## **Environmental Planning Commission**

**Agenda Number: 07**  
**Project Number: 1005354**  
**Case #: 16EPC-40059 & 40060**  
**November 10, 2016**

### **Staff Report**

<b>Agent</b>	Design Plus, LLC
<b>Applicants</b>	Sawmill, LLC
<b>Request</b>	<b>Site Development Plan for Subdivision Amendment</b>  <b>Site Development Plan for Building Permit Amendment</b>
<b>Legal Description</b>	Tract 2-D-1, Arbolera de Vida Unit 2B, and Lot 2, Correction Plat of Sawmill Village; Lots 3 through 10, Correction Plat of Sawmill Village; Lots 1-A, 1-B and 1-C Sawmill Village
<b>Location</b>	On Bellamah Ave. NW, between 18th St. NW and 19th St. NW
<b>Size</b>	Approximately 10 acres
<b>Zoning</b>	SU-2/SU-1 for PRD and SU-2/SU-1 for PRD and Microbrewery

SITE DETAILS  
V.2  
SDP 1.2  
SHEET 07

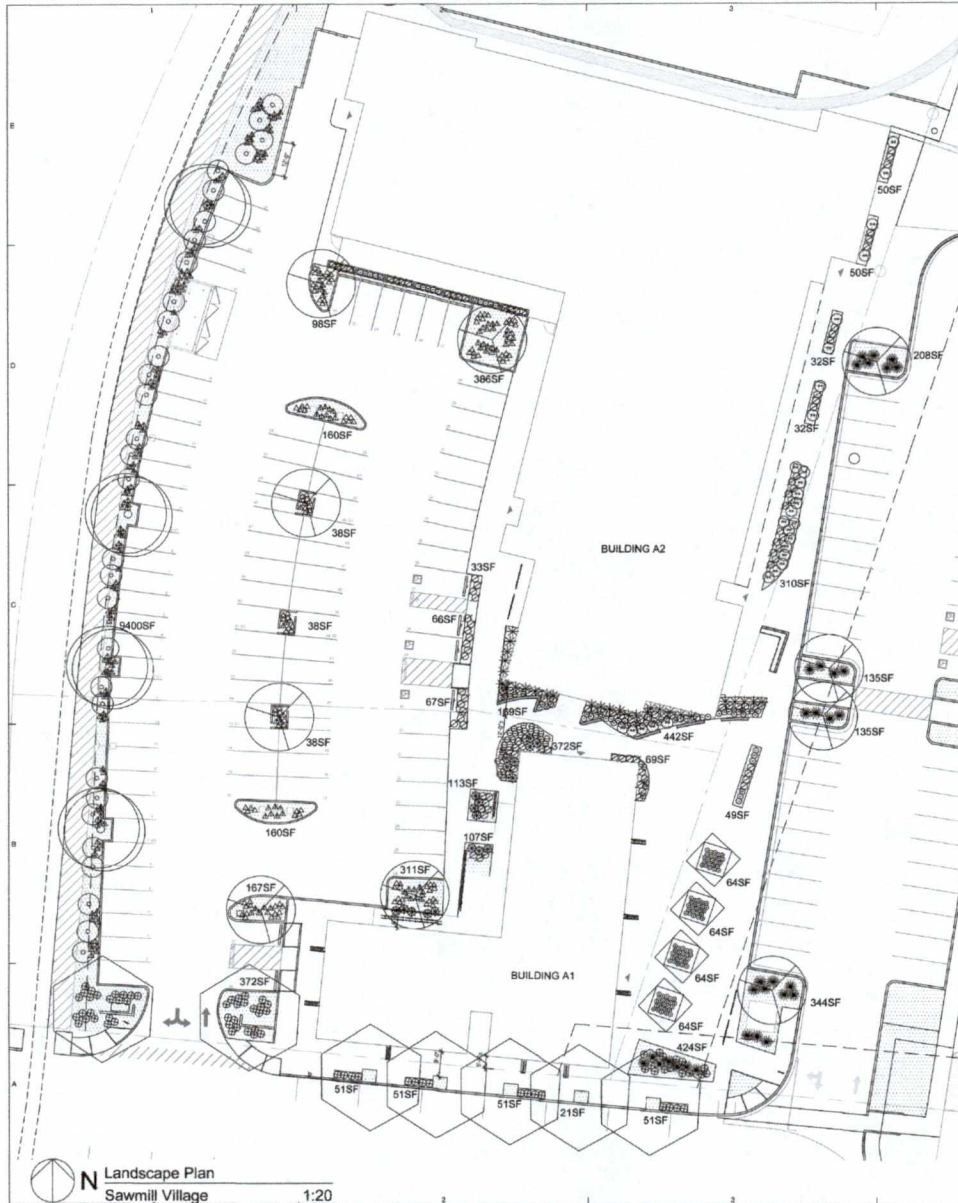
The design standards require that fencing along the subject site's western boundary is similar to the fencing at the adjacent Sawmill Lofts (to the west), meaning that it is a 6 foot high, metal picket fence painted a neutral color. A fence detail, indicating height, color, and materials, is needed to evaluate compliance.

The fence near the detention pond is required to be a steel, open rail fence. A fence detail is needed to ensure that this fencing meets the design standards.

The 3.5 foot screen wall, which faced Bellamah and screened 5 parking spaces, is no longer proposed. A 6 foot fence is proposed along the western side of the Phase II development. A fence detail, specifying material and colors, is needed to ensure compliance with the design standards.

V.2  
 SDP 2.0  
 SHEET 1 OF 3

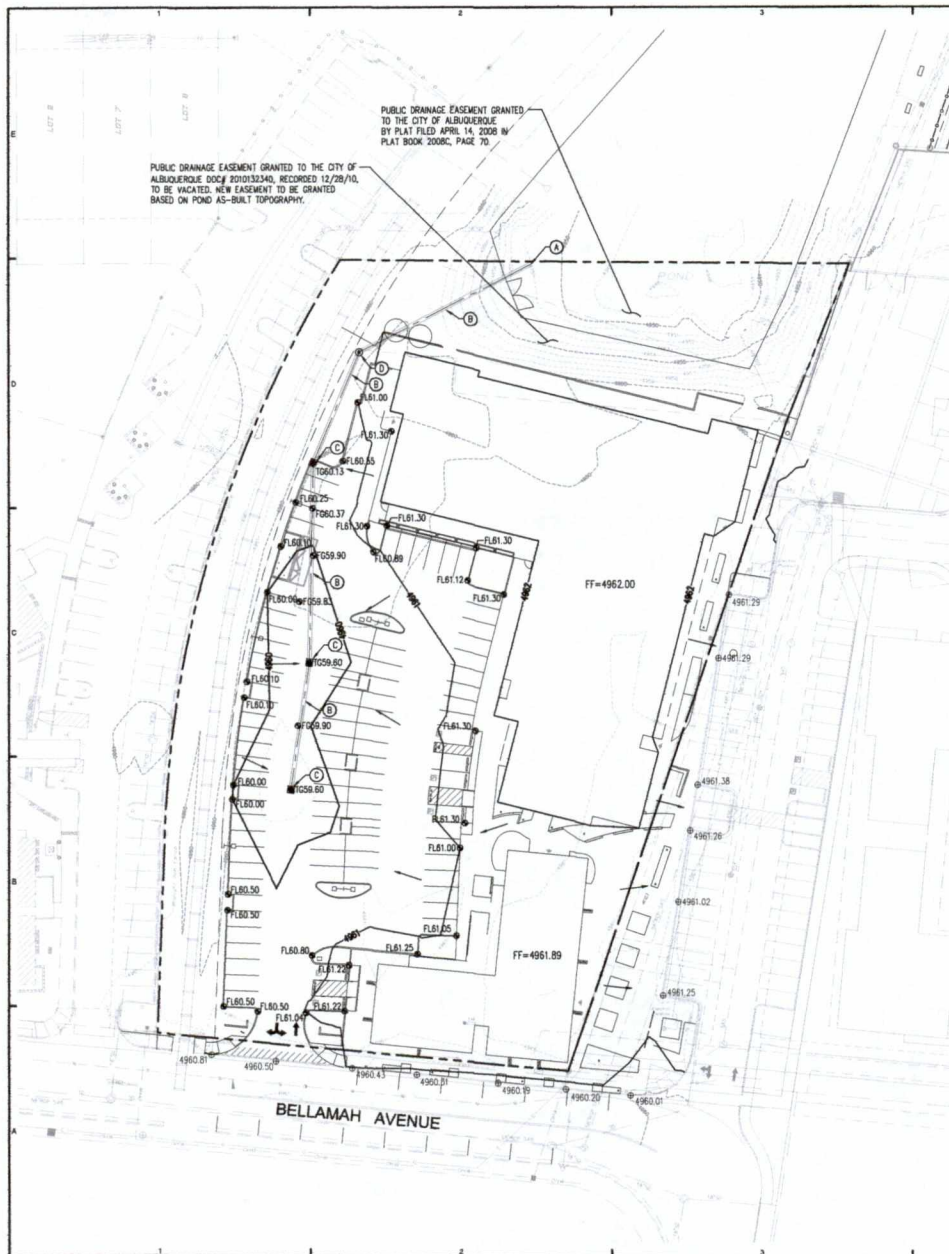
A landscaping plan for the Sawmill Village site was approved in 2011. The current amendment includes changes to the Phase I portion of the landscaping plan. Two fewer trees would be located along the site’s eastern side. Staff recommends that one of the trees (the northernmost one) remain as in the approved landscaping plan—especially since a trail is intended to run along this western edge of the site. The Solid Waste Management Division does not want a tree near the dumpster, so Staff is recommending that the other tree originally approved not be there (which the current submittal reflects).

short (often used beneath power lines), and because the multi trunks do not provide the type of shading needed for pedestrians. Staff suggests going back to Red Oak as originally approved, or using Chitalpa, which is now proposed on the plant palette.

Another issue is the reconfiguration of the landscaping beds between buildings A-1 and A-2. At one point, the planters are so close that only 3 feet is available between them. This is an impediment to pedestrian circulation. It would be preferable if the beds attached to Building A-2 were not angular, and the beds at the NW corner of Building A-1 not be so large and circular. The landscaping requirement is being met sufficiently, so the reduction in landscaping bed space would not create non-compliance with landscaping requirements.
